LEGACY AT MOSS PARK PLAT

The applicant is requesting Major Plat ap-
proval for a 62 townhome development.

Major Subdivision Plat

BOUNDARY SURVEY

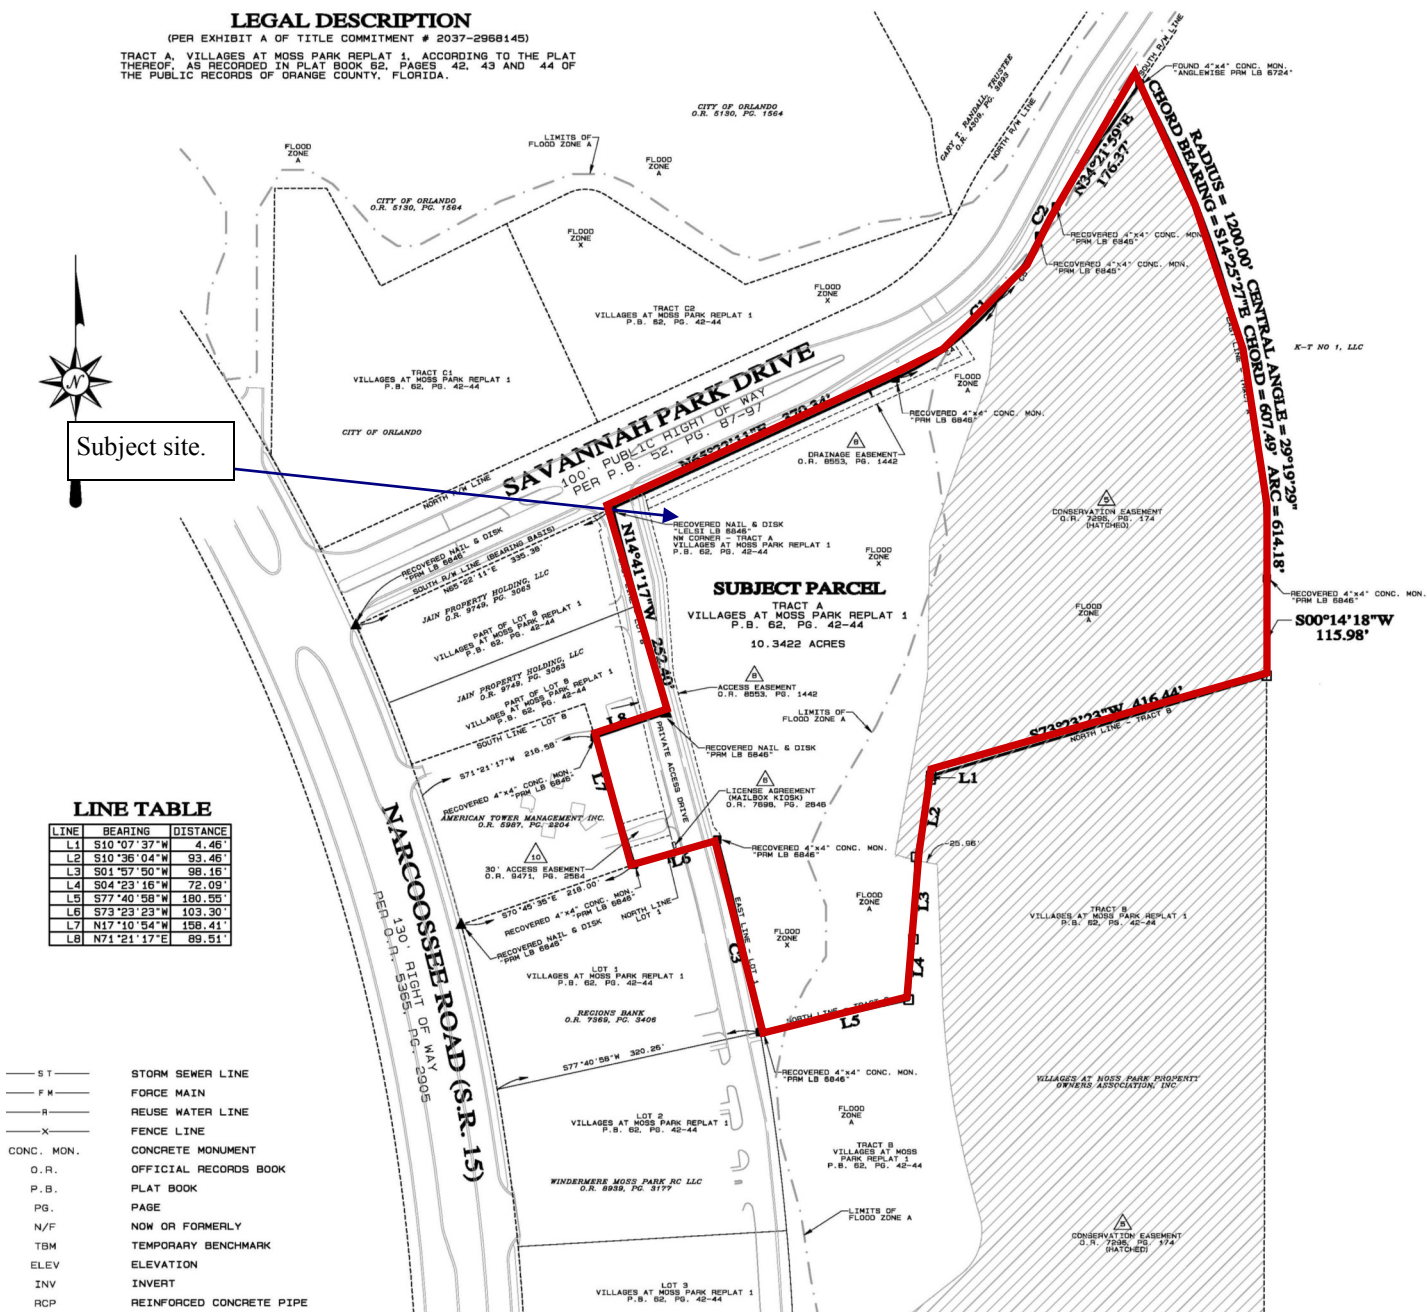
The applicant is requesting major subdivision plat approval to divide the one existing parcel into 62 lots and several tracts. Tract T contains the private streets and alleyways, excluding the private access drive that currently exists along the west property line. The private access drive is currently in an access easement shared amongst the Villages at Moss Park parcels. Tract T contains 3 proposed streets (Chatman Dr., Cranford Dr., and Clairbridge Dr.) and 3 alleyways (Fairmount St. and Thornwood St.). The name Fairmount St. was used twice for two of the alleyways and therefore one alleyway needs to be renamed. Tract A contains the conservation easement along the eastern portion of the lot. Tracts B-M and O-S contain common areas used for open space. Two tracts are labeled 'M' while there is no tract 'N', this needs to be corrected.

PROPOSED PLAT

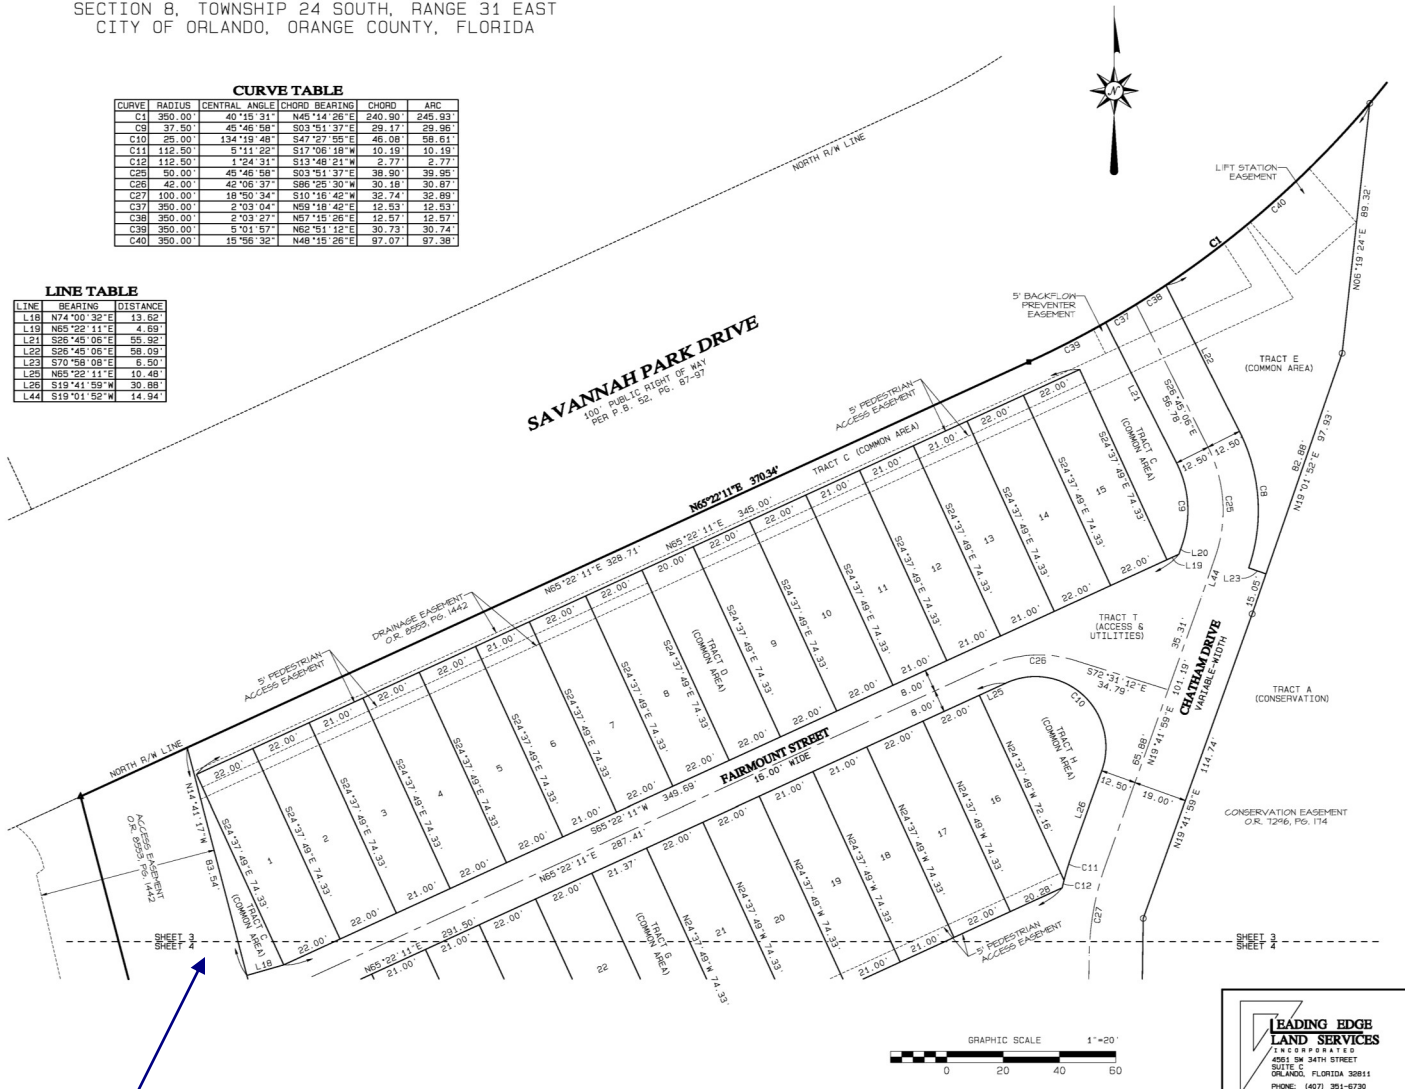
Both alley-
ways name
Fairmount St.

1. General Code Compliance. Development of the proposed project shall be consistent with the conditions in this report and all codes and ordinances of the City of Orlando, the State of Florida and all applicable regulatory agencies. All other applicable state or federal permits must be obtained before commencing development.
2. Previous Approvals Consistency. The proposed development shall be developed consistent with the conditions of the approved Master Plan and Villages of Moss Park PD.
3. OUC Metering. An individual residence metering system shall be utilized.
4. Tract N. One of the two Tracts labeled 'M' shall be renamed to 'N'.
5. Alleyway Name. Two alleyways are named Fairmount Street. Please rename one.
